Access Compliance Report

Public Rights-of-Way

| Intersection ID: N/A | Main Street: STEELE_CREEK_RD | Cross Street: N/A | Location: SW |
| ADA ID: 38041E7634E5 | Ramp Type: Perp | Initial Pass/Fail: Fail | Overall Compliance: No |

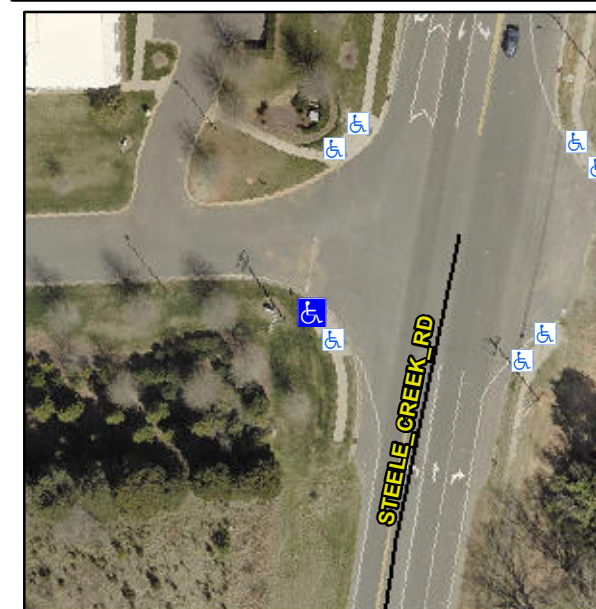
Not Found, R304.2.2

| Compliance | Description | Data | Compliance | Description | Data |
|------------|-----------------------|------|------------|-----------------------------|------|
| N/A | Ramp Length (in) | 59.0 | No | Ramp Slope (%) | 8.7 |

Remove & Replace Entire Ramp.
